BLUE BIRD

GM 8.1 Knock Sensor

MODELS AFFECTED: 2009 & 2010 Propane Visions

S10RN

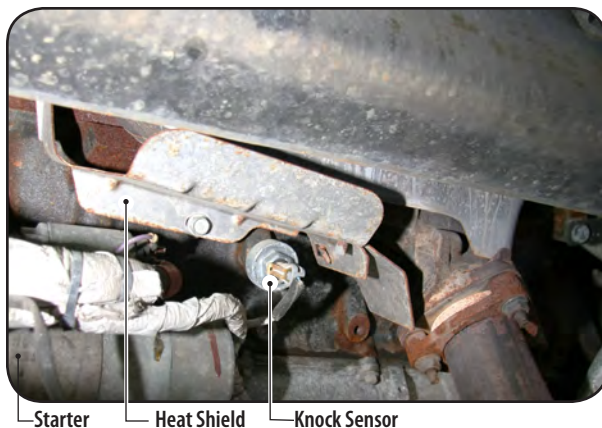
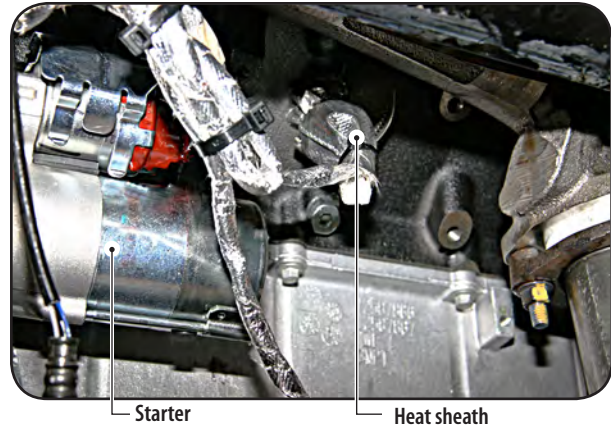
The GM knock sensor may fail due to a heat shield having been eliminated on some GM 8.1 engines.

Inspect knock sensor and install a heat sheath if neither heat shield nor heat sheath is not present.

4 Install protective sheath to knock sensor, as follows:

- 4.1 Disconnect sensor harness from knock sensor.
- 4.2 Slide heat sheath onto sensor harness and place clamp over sensor on engine.
- 4.3 Reconnect sensor harness to sensor, slide heat sheath over knock sensor and electrical connection all the way to the engine block.
- 4.4 Position clamp over heat sheath between sensor body and sensor mounting boss. Do not clamp on top of sensor body.
- 4.5 Tighten clamp. Do not over-tighten clamp as damage to knock sensor may occur.
